SERVICE BULLETIN

M-1208

Safety Recall Code 0131

2006-2007 XL EXHAUST SHIELD RECALL

Figure 1. Inner Exhaust Shield Installation on Rear Exhaust Pipe

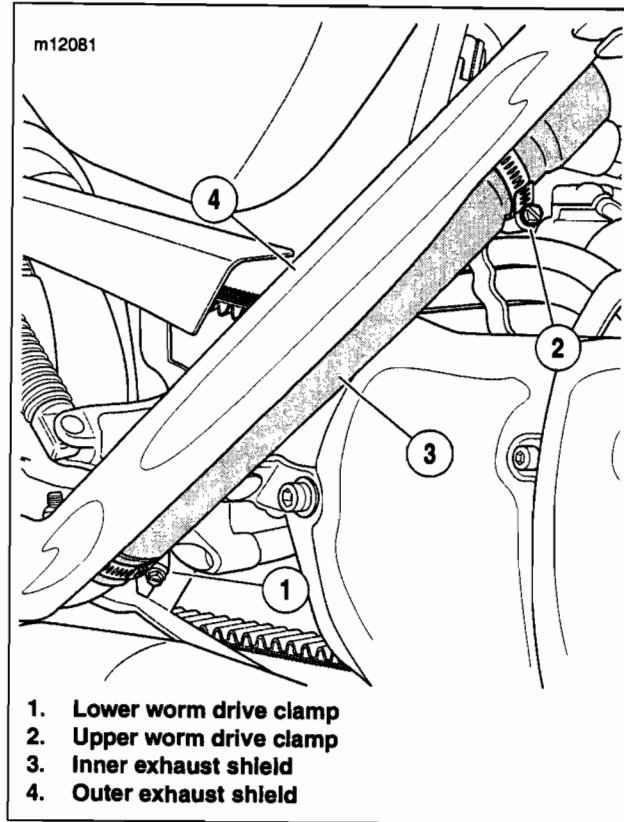
Harley-Davidson has determined that a condition affecting motor vehicle safety exists on 2006 and 2007 XL1200L models and 2007 XL1200N model vehicles. These vehicles have a condition whereby the pant leg of some riders can have direct contact with the exhaust pipe. This condition could cause the pant leg to char or burn, which could lead to the possibility of injury to the rider.

In the interest of motor vehicle safety and customer satisfaction, Harley-Davidson has elected to initiate a voluntary recall (0131). Recall 0131 consists of installing an additional exhaust shield on the inner side of the rear exhaust pipe, preventing the risk of the rider pant leg having direct contact with the exhaust pipe. You may sell but not deliver any affected motorcycles to your customers until the remedy is completed.

See Figure 1. If the vehicle is equipped with an original rear exhaust pipe (header) which does not have the inner exhaust shield installed, proceed to the installation instructions.

1. See Figure 1. Loosen the lower worm drive clamp (1) on the rear exhaust pipe.
2. Completely unfasten the upper worm drive clamp (2) until the clamp opens.
3. Slide the bottom portion of the **new** inner exhaust shield (3) against the exhaust pipe and into the lower clamp. The clamp should rest on the indented portion of the inner exhaust shield.

During installation, position the worm drive clamps so the screws are on the outboard side in the most accessible position.

4. Tighten lower clamp securely.
5. Place the upper portion of the inner exhaust shield against the exhaust pipe.
6. Install the upper clamp over the indented portion of the inner exhaust shield. Tighten clamp securely.
